COSTILLA DRAINAGE BASIN STUDY

PREPARED FOR THE COLORADO SPRINGS DEPARTMENT OF PUBLIC WORKS

George L. Williams - Consulting Engineer

Sept. 23, 1968

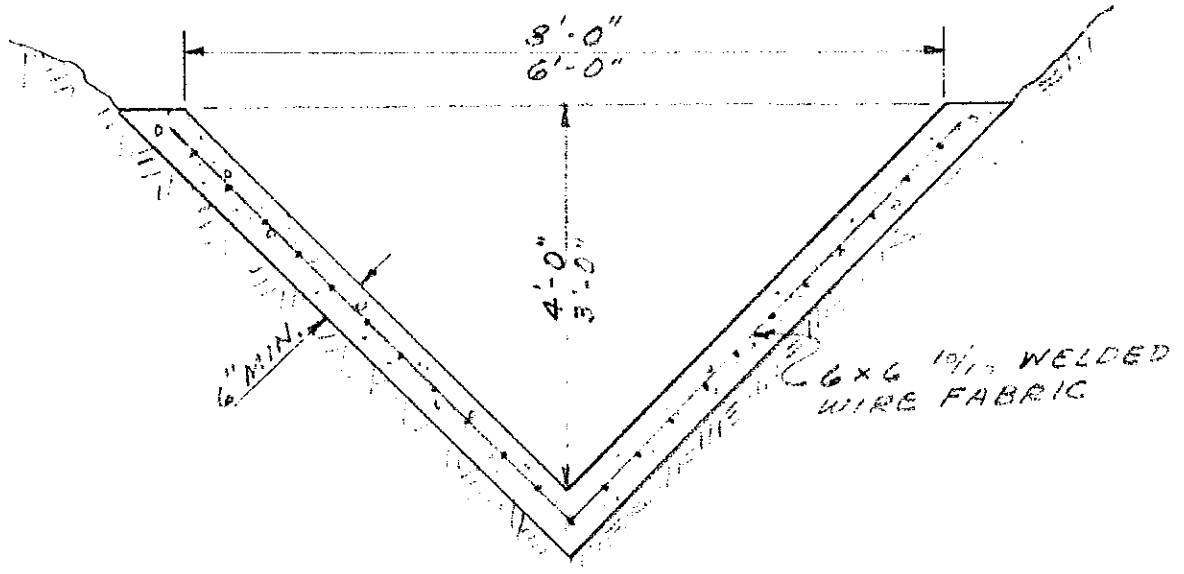
*why not ditch @ 18" or 18" ?*
